DATE: September 18, 2023
TO: All Bidders
FROM: Renée Knight, Purchasing Specialist
SUBJECT: Addendum 1 – Bid #657, Oxnard College Automotive Technology Vehicle Lift

ADDENDUM 01

OXNARD COLLEGE AUTO TECH
Ventura Community College District
4000 S Rose Ave.
Oxnard, CA 93033

Item No. AD-01-1 **RFI responses**

P201

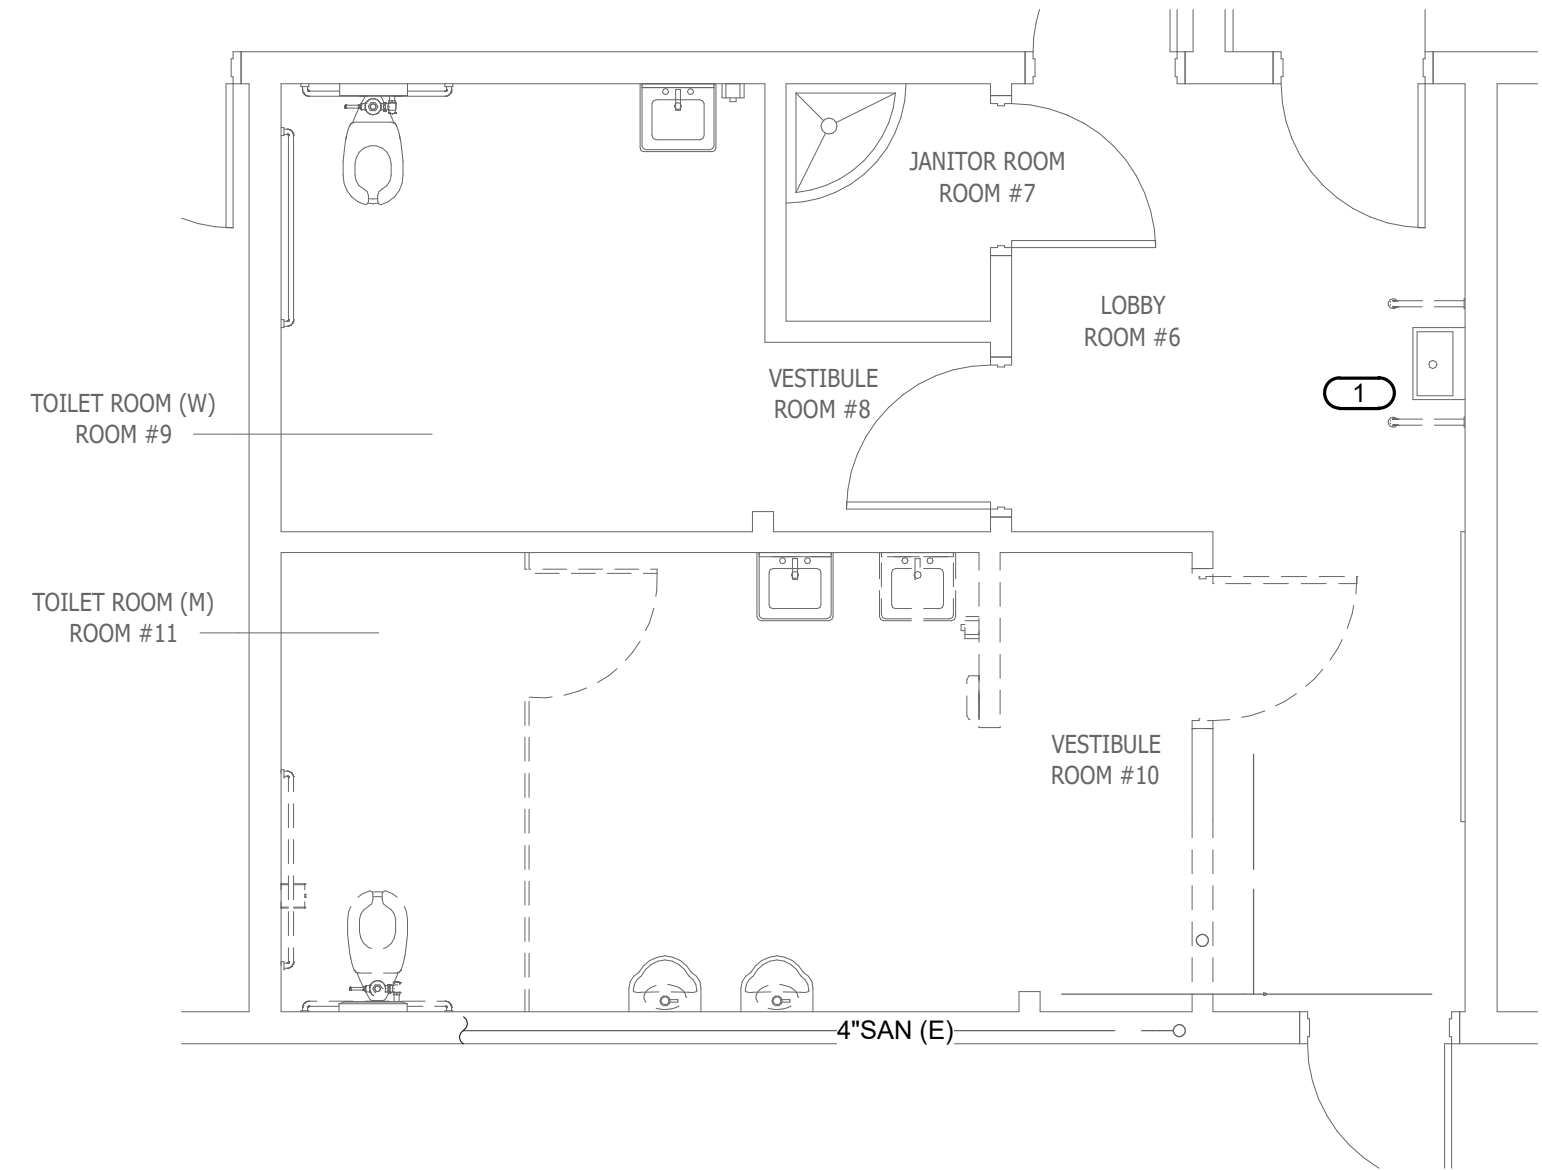
2. P201 ENLARGED DEMOLITION AND REMODEL RESTROOM PLUMBING PLANS

- a. This is a new sheet, including demolition and remodel plans of new drinking fountains.
